Radiological Health Review
of the Draft Environmental Impact Statement (DOE/EIS-0026-D)
Waste Isolation Pilot Plant, U. S. Department of Energy

Robert H. Neill, James K. Channell, Carla Wofsy,
Moses A. Greenfield, Editors

Environmental Evaluation Group
Environmental Improvement Division
Health and Environment Department
State of New Mexico

August 1979

Figure 3:
 Composition diagram
 for water sample
 of table 7.22

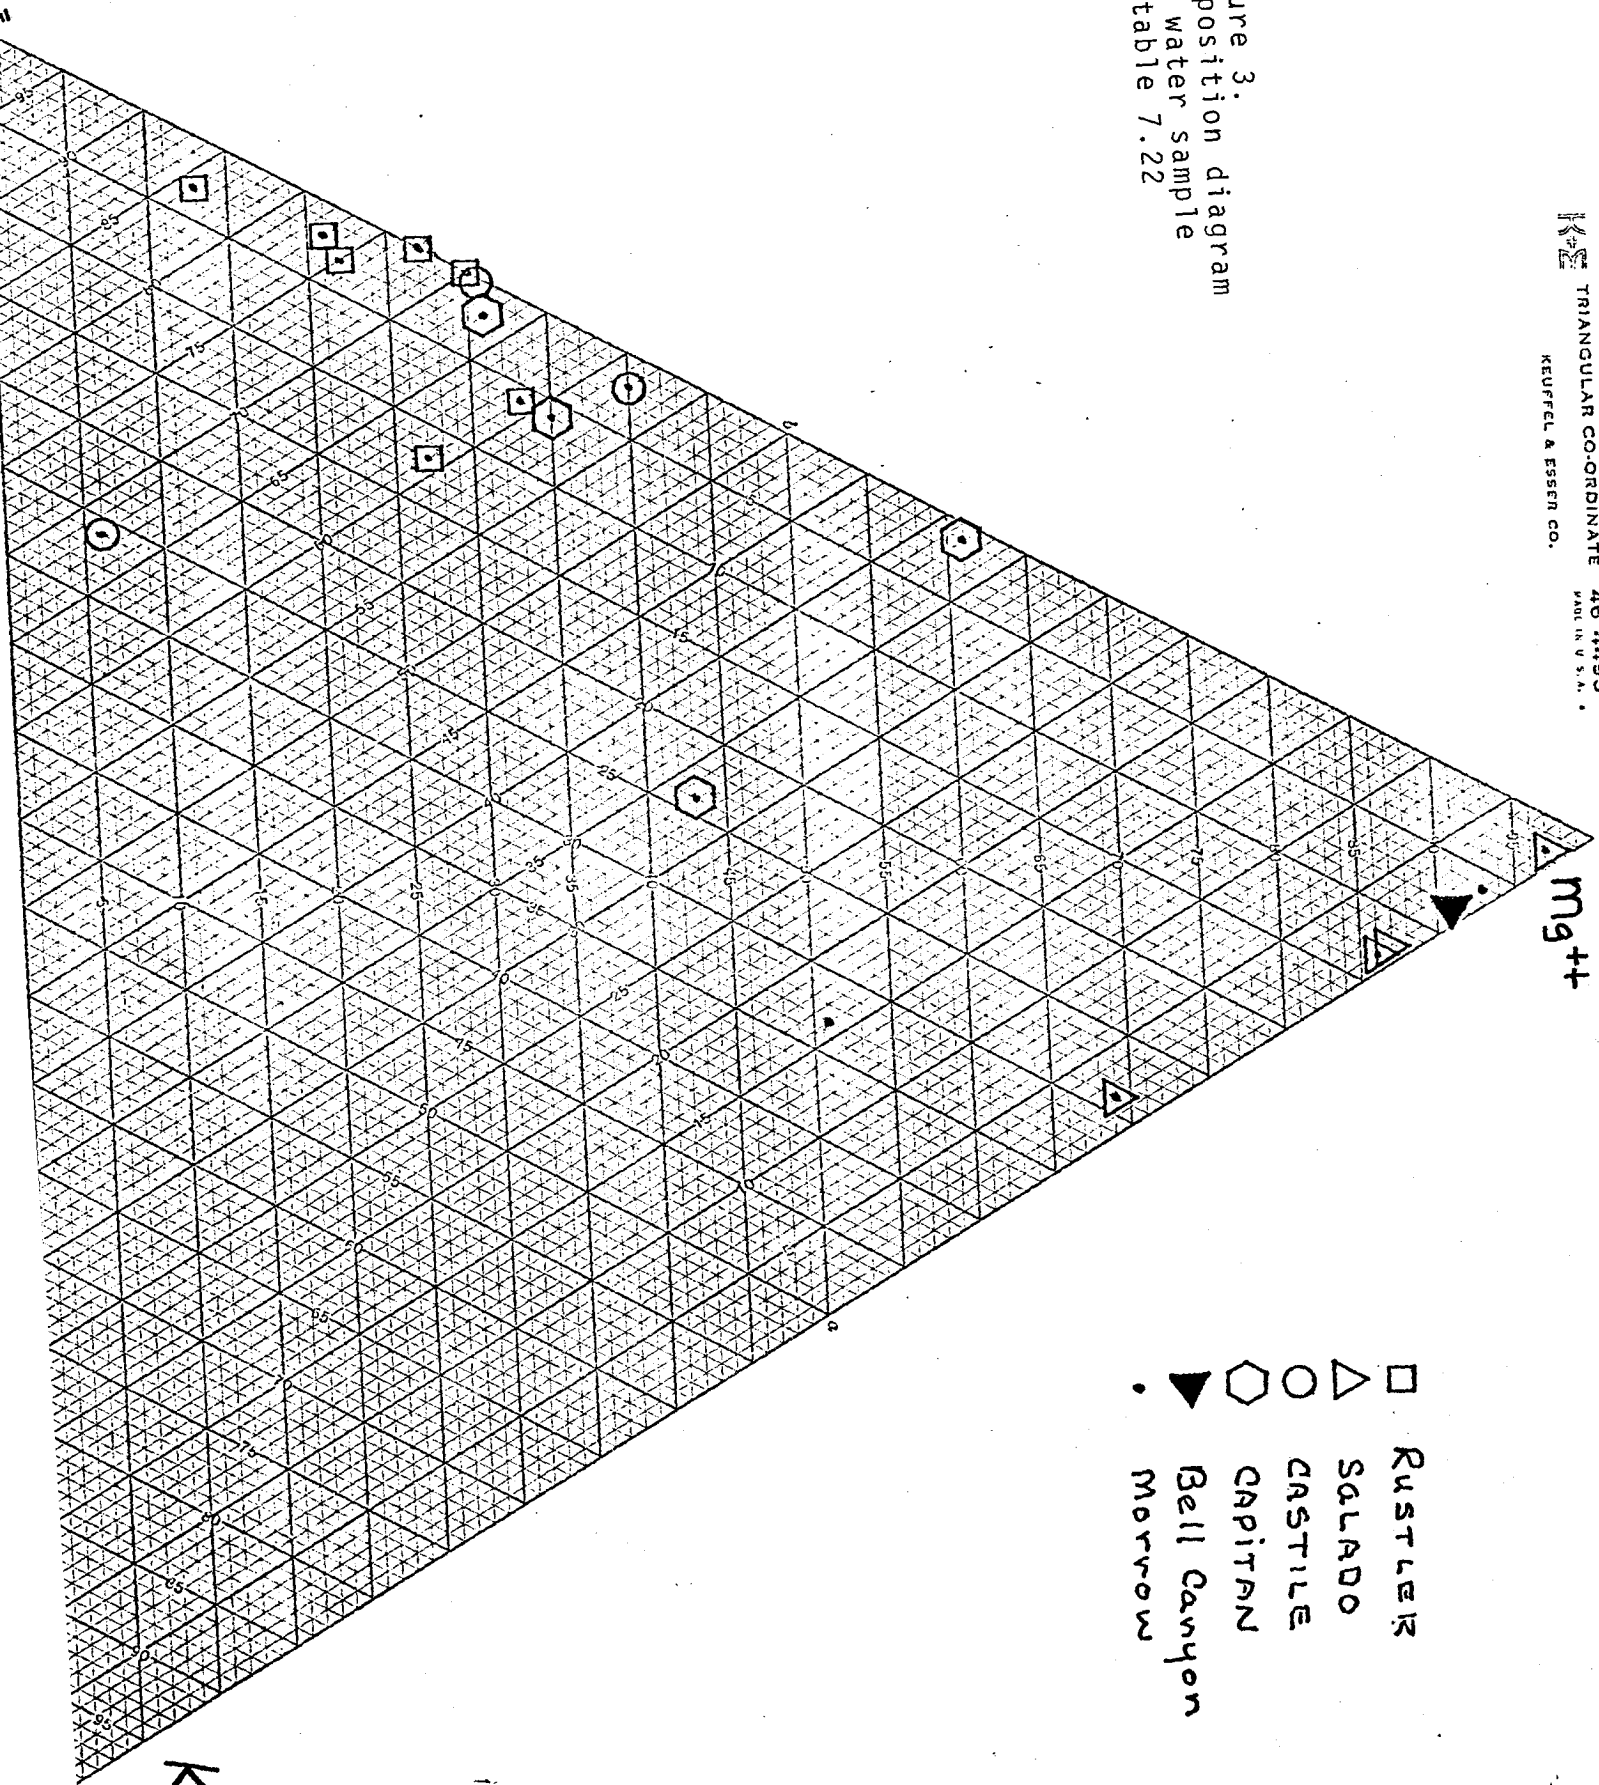
These points suggest the possibility that ERDA No. 6 water has recently been in contact with dolomite and calcite, e.g. the Capitan limestone and associated dolomites (Figure 3.3-2) or the Bell Canyon formation which "contains considerable limestone interbeds and lime rich intervals" and whose top unit consists of limestone (Figure 4.3-2). Two possible routes for water movement from the Capitan reef were suggested by Anderson (1978, pp. 69, 72): along the contact between the Castile and Salado formation, or moving upward from the Bell Canyon formation through fractures in the Castile formation.

None of the questions posed on (7-90) concerning the ERDA No. 6 reservoir are resolved with any degree of certainty by the geochemical information in Chapter 7; all that can be said is that the origin and evolution of such brine reservoirs in the evaporites remains a mystery.
